Amendments to the Drawings:

Application No.: 09/811200

Title: APPARATUS FOR MAKING MULTILAYER OPTICAL FILMS

Fig. 3

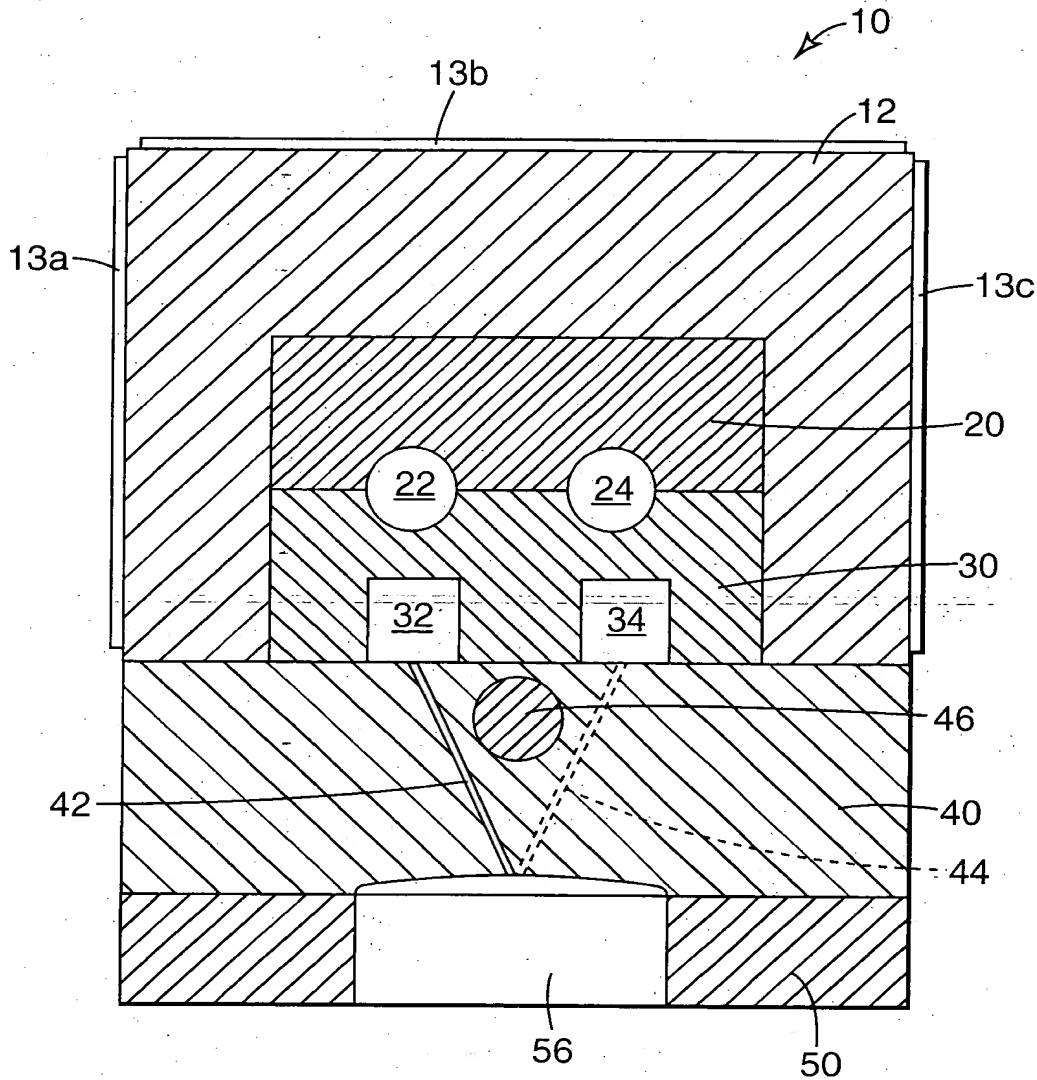
Please amend FIG. 3 to include representations of plate-type heaters, as shown on the attached drawing sheet which is labeled "Replacement Sheet". Amended FIG. 3 differs from the previous version of FIG. 3 by the addition of three rectangular shapes labeled 13a, 13b, and 13c, which shapes schematically represent plate-type heaters as described in the specification. Reference numerals 20 and 30 have been moved slightly and their lead lines extended to accommodate the new shapes. No new matter has been added.
